R01FF

July 30, 2001

Blue Bird Body Company has determined that a defect which relates to motor vehicle safety exists in certain Blue Bird TC/2000 rear engine buses, Commercial Series rear engine buses and Q-Bus rear engine buses manufactured from 1996 model year through May of 2001 model year. Blue Bird is conducting a recall to correct this defect.

The defect involves the 12-volt power supply cables on subject buses. The cables may contact the chassis frame, rest against the engine or engine components and chafe through the wiring harness protective loom.

Battery Cable Routing and Reinstallation.

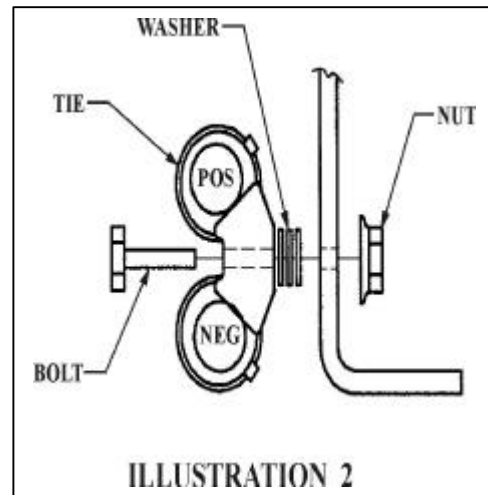
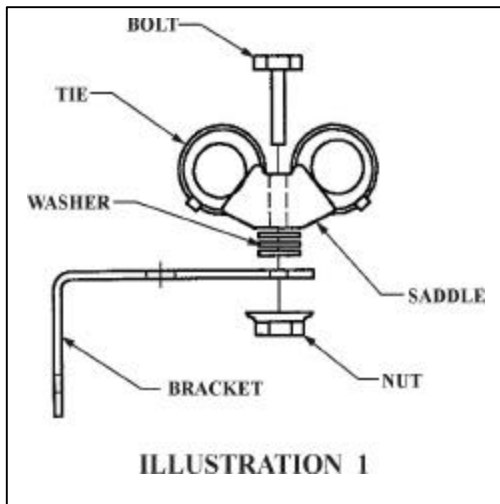
- I. Having noted the routing of the cables before removal, install the 2-way saddle mounts to support cabling along the frame rail and crossmember. The use of brackets to support the saddle mounts may be necessary providing the required clearance to other cables or lines. The heavy-duty mount can be used for single electrical cable requirements. Refer to the illustrations for assembling the saddle mounts.

- J. Existing locations should be used to mount hardware. Battery cables can be supported at shared locations with other clamps. Please note the following guidelines when installing hardware.
1. The battery cables must be routed independent of all other cables, lines, or hoses.
 2. Cable mounts should be at a maximum interval of 24 inches and secured as close as it is permitted to all cable bends.

FIGURE 1

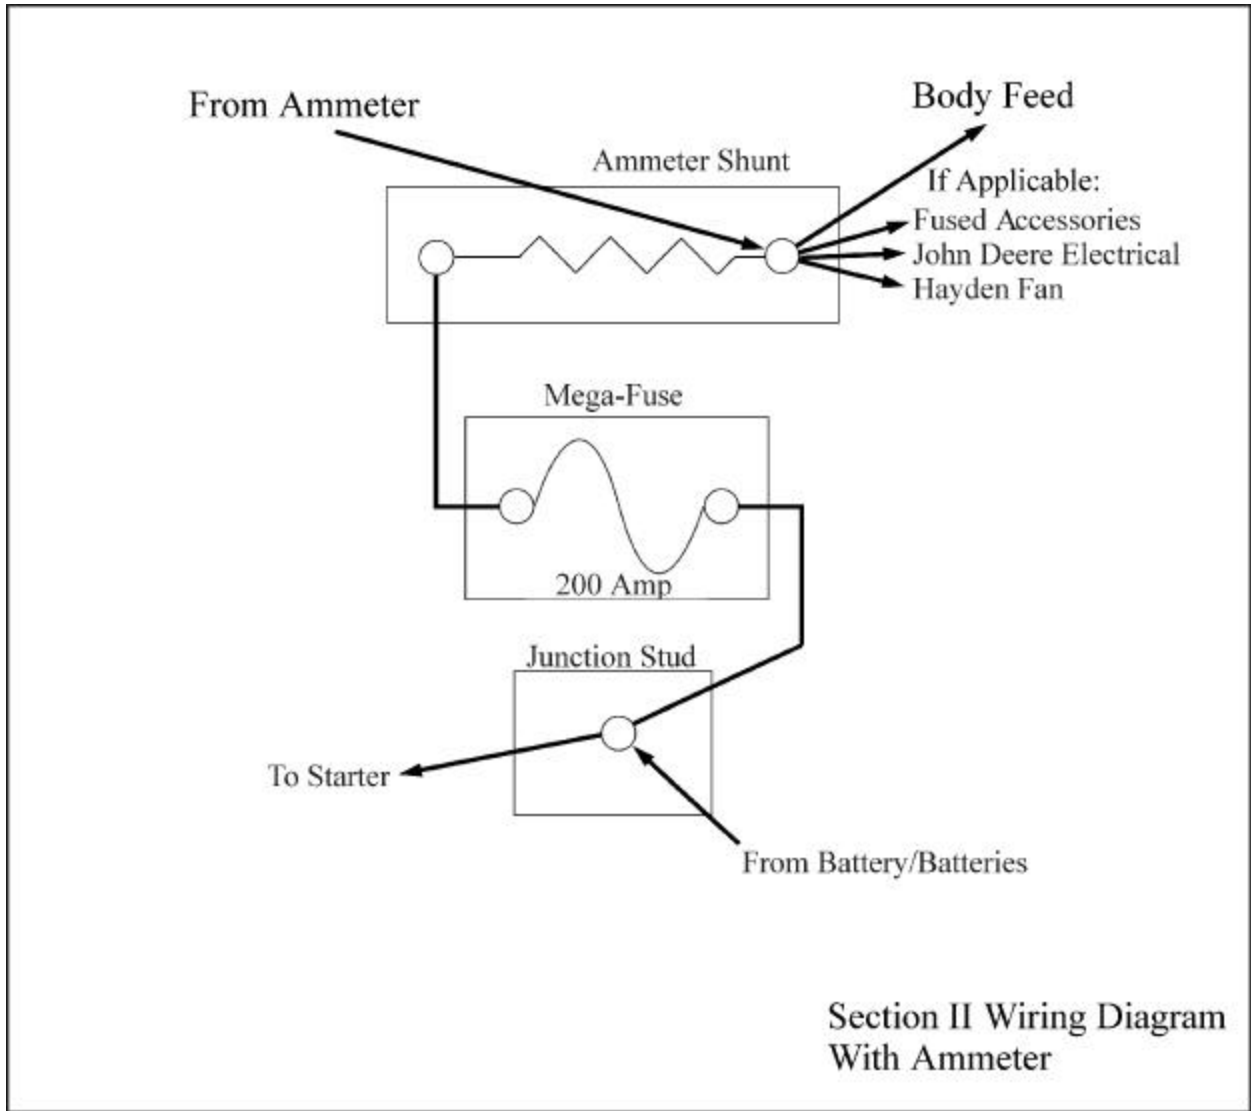
- D. Refer to Figure 1 (for units with ammeter) on page 5 and Figure 2 (for units without ammeter) on page 6 for the proper cable and wiring connections. Install the Mega-fuse and cable assemblies between circuits as required. Position the Mega-fuse to prevent interference to other wiring components.

- E. Secure all threaded electrical connections. Torque 5/16 inch hex nuts to 10 ft./lbs. and 3/8 inch hex nuts to 20 ft./lbs. Coat cable ends and terminal posts with electrical grade silicone RTV or Glyptal enamel.

- F. Modify (trim) fuse cover, as needed, to allow for cable clearance. Install cover and check all cables and wire routing.
